City of Richmond Hill
Design Review

Site Plan Statistics	
Zoning	ZBL 55-15, MZO 698-20
Lot area	384.30 sq m
Building area	154.78 sq m
Lot coverage (55% max.)	40.3 %
Storeys (4 storeys max.)	2

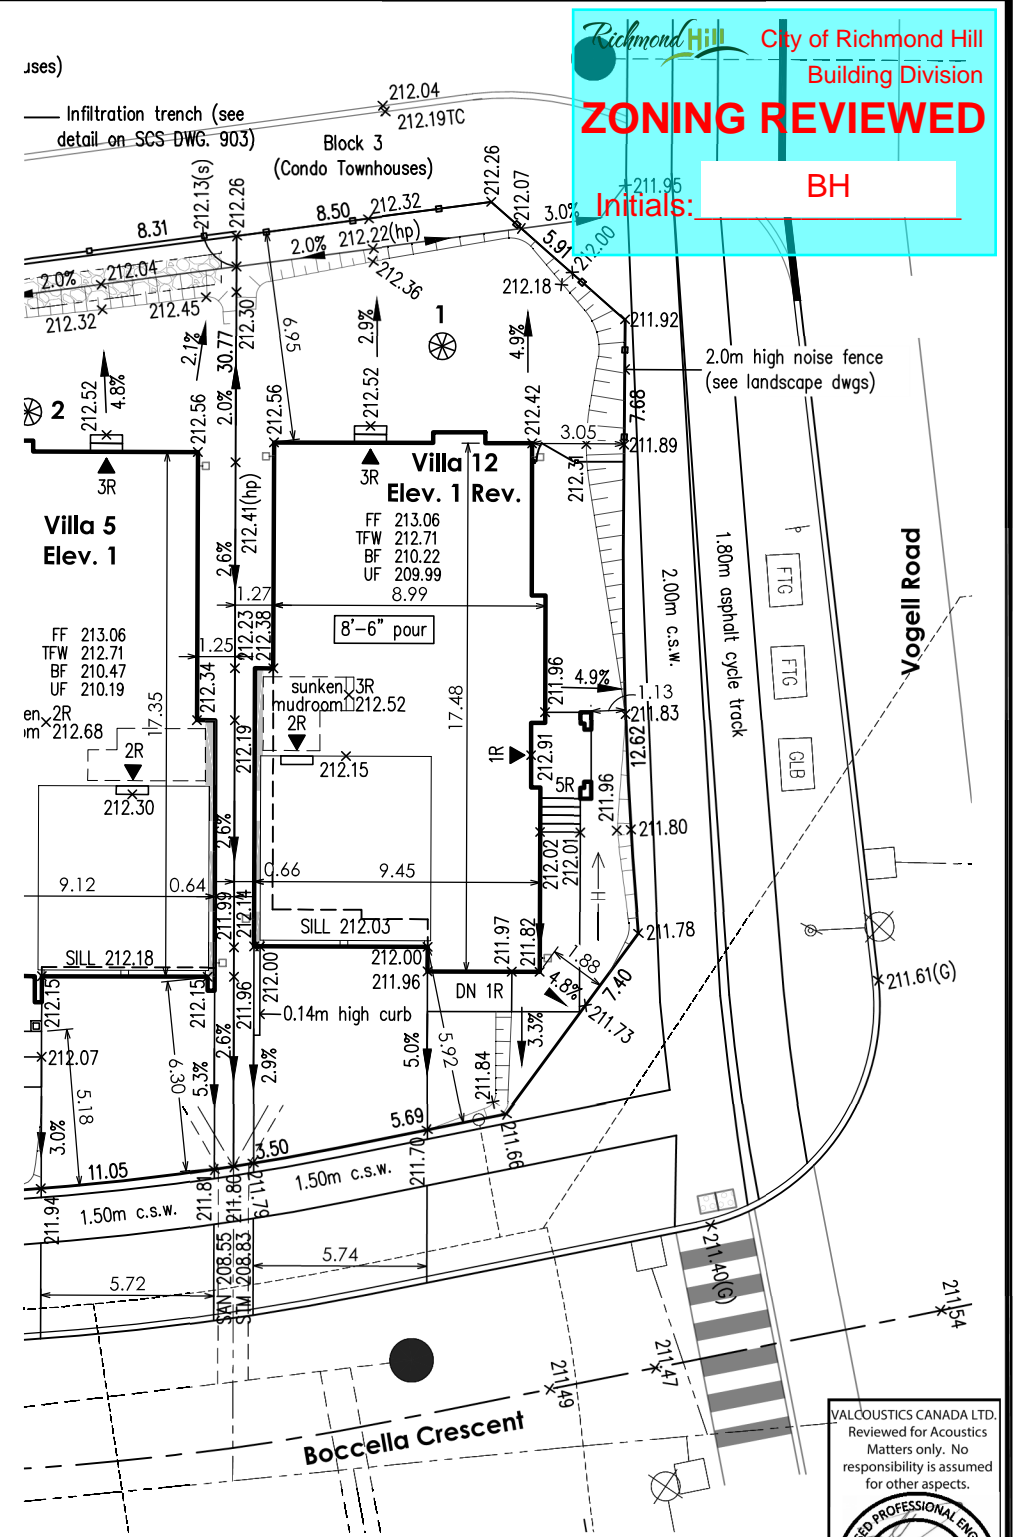
VCL Comments:
1. Dwelling requires Mandatory
AC conditioning.
2. Dwelling requires upgraded
Exterior facade. See Noise Report.
